### APPEAL SUMMARY

<b>Appeal ID:</b> 21954	<b>Project Address:</b> 151 SW 1st Ave
<b>Hearing Date:</b> 10/2/19	<b>Appellant Name:</b> Tom Jaleski
<b>Case No.:</b> B-015	<b>Appellant Phone:</b> 9712385266
<b>Appeal Type:</b> Building	<b>Plans Examiner/Inspector:</b> John Cooley
<b>Project Type:</b> commercial	<b>Stories:</b> 5 <b>Occupancy:</b> B, M, S-1 <b>Construction Type:</b> III-A
<b>Building/Business Name:</b> PAE Living Building	<b>Fire Sprinklers:</b> Yes - Throughout
<b>Appeal Involves:</b> Erection of a new structure, Reconsideration of appeal	<b>LUR or Permit Application No.:</b> 19-124284-LU
<b>Plan Submitted Option:</b> pdf [File 1] [File 2] [File 3] [File 4]	<b>Proposed use:</b> Office, Retail

# PAE Living Building

## Engineering Judgment Report #1

1 **EXTERIOR WALL ASSEMBLIES**  
EX3-D 1 1/2" = 1'-0"

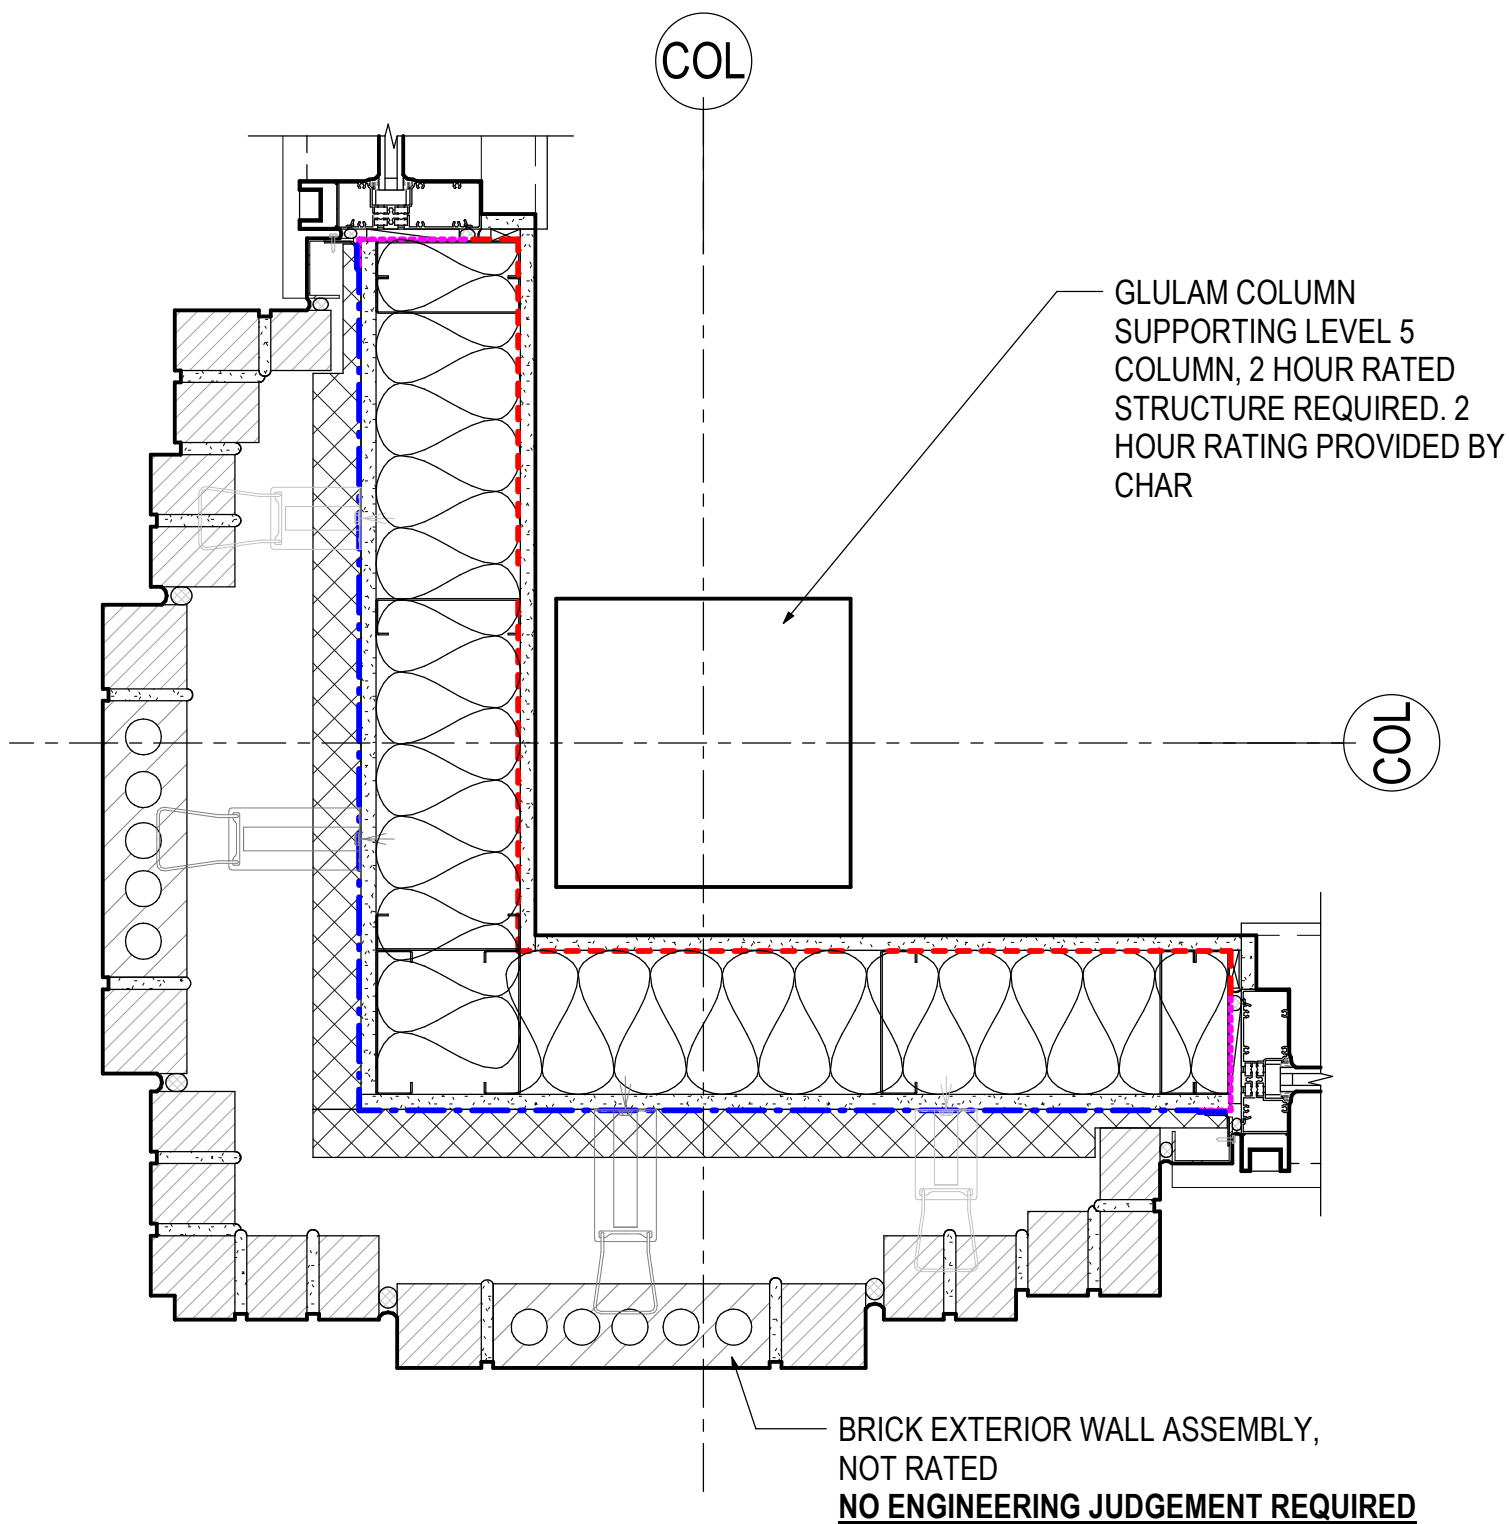
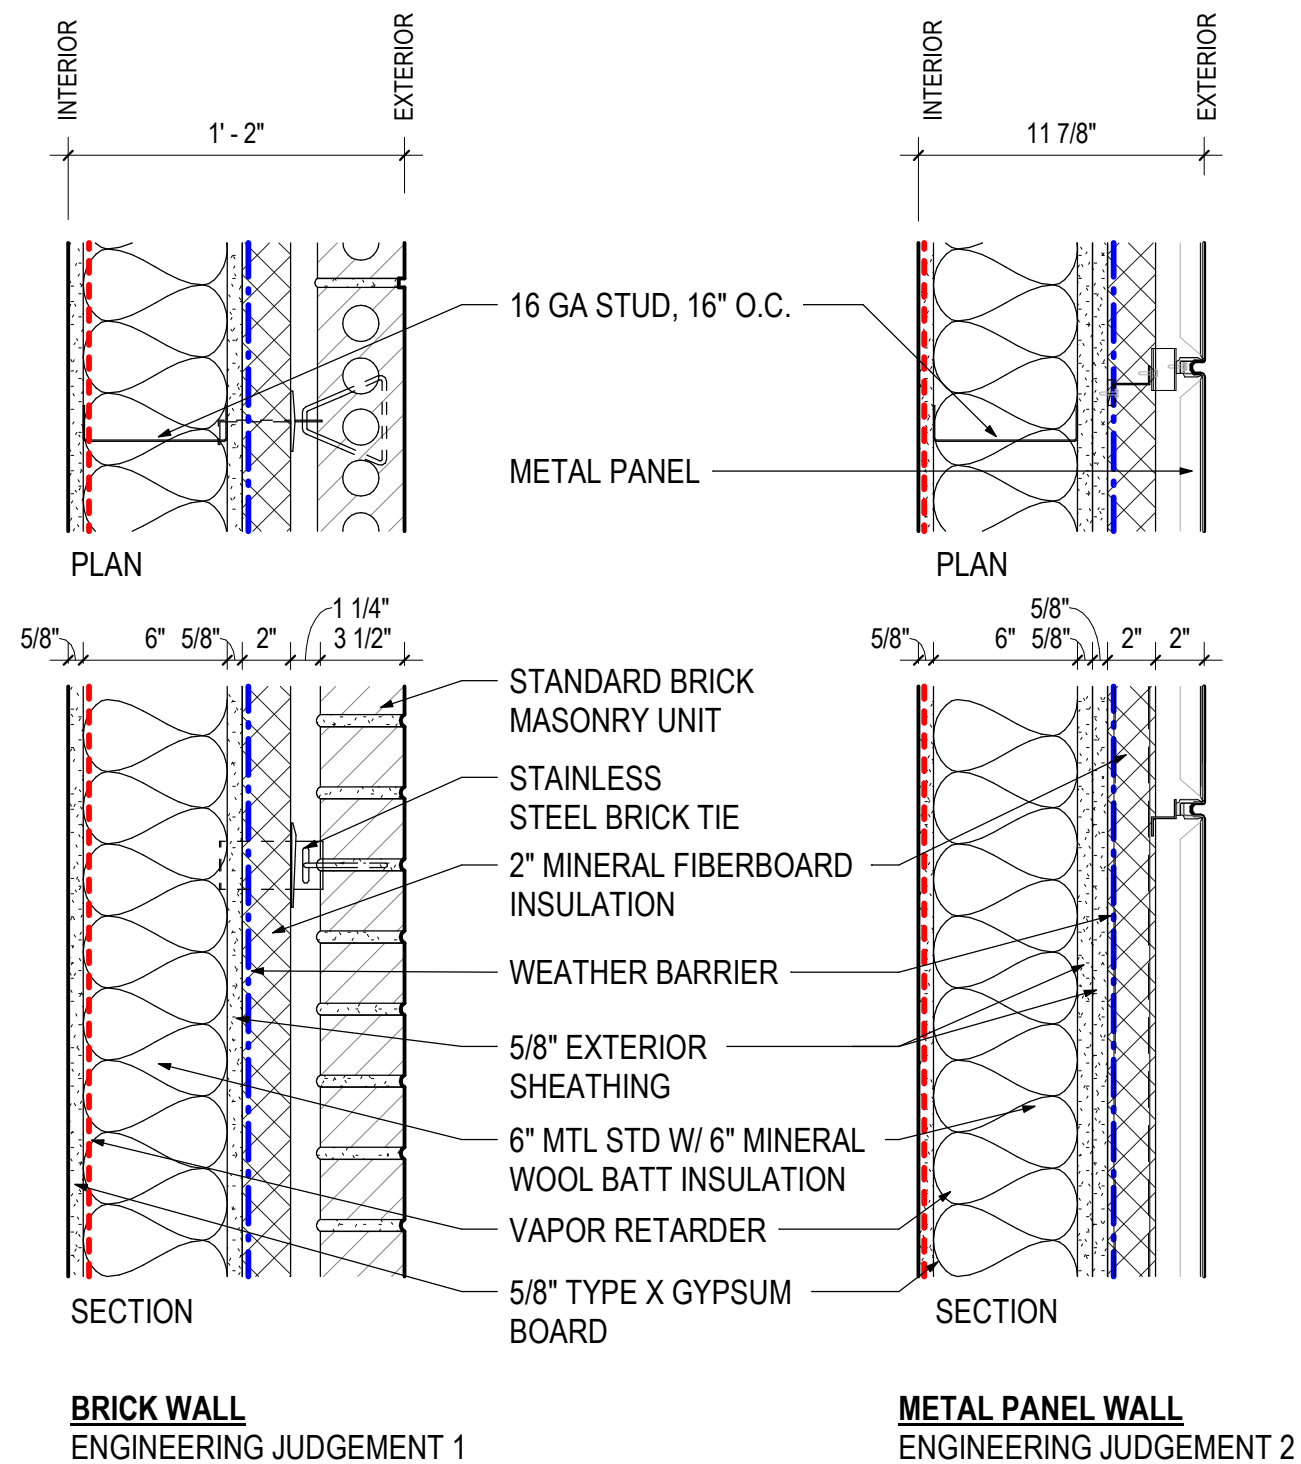
Refer to the attached Exhibit 3. Included are floor plans and details that indicate the relationship of the exterior wall to the primary structural frame. The nonbearing exterior wall assembly, consisting of interior finish membrane, wall structure, insulation and exterior finish, is provided as required between the conditioned interior space and the exterior space. In all cases, unless noted otherwise on the plans, we have designed the structure to be completely within the conditioned interior space of the exterior wall assembly. The exterior wall spans from the CLT floor decks. In cases where the structure is engaged in the exterior wall or on the exterior side of the wall, we are providing the required 2-hour rating at the primary structure, and all elements that support that structure will also be 2-hour rated. Those locations are indicated on the attached exhibit drawings.

On levels 1 and 5 on the South and East exterior walls, there are recesses between the column bays. In those locations the structure is still completely on the inside of the inner most exterior wall layer, and per Table 601 will require 1-hour rating. We are proposing an additional layer of 5/8" type X gypsum board on the interior side at the walls surrounding the structure in order to provide a 2-hour rated exterior wall assembly. These locations only occur on the street facing walls with a fire separation distance of greater than 30', and the locations on the 5th floor are over 56' above grade level.

### **Alternate 2 hour wall assemblies with engineering analysis: Granted as proposed.**

**PLAN DETAIL - PILASTER AT LEVEL 1 RECESS**

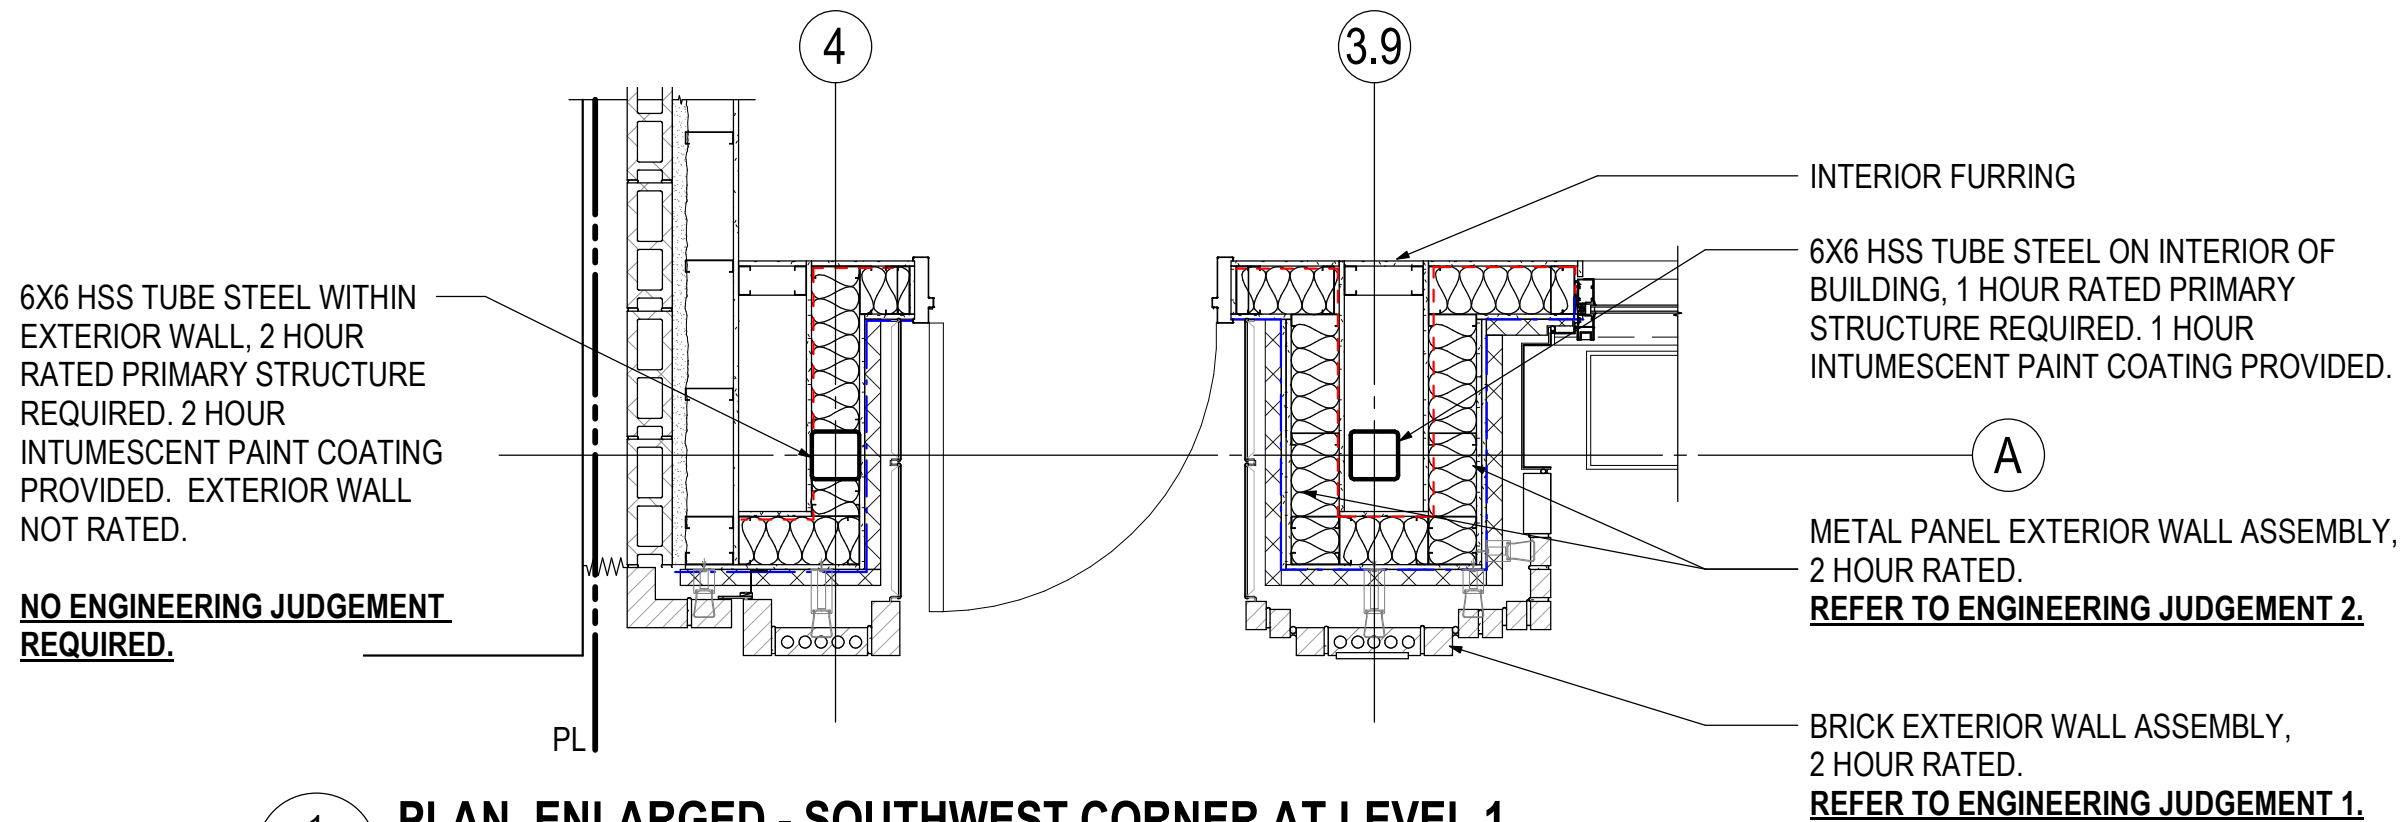
On levels 1 and 5 on the South and East exterior walls, there are recesses between the column bays. In those locations the structure is still completely on the inside of the inner most exterior wall layer, and per Table 601 will require 1-hour rating. The exterior wall assemblies on all sides of the columns and beams will be designed to provide a 2-hour protective rating from the exterior side, this will protect the primary structure from any fire risk on the exterior of the building. These locations only occur on the street facing walls with a fire separation distance of greater than 30', additionally the locations on the 5th floor are over 56' above grade level.
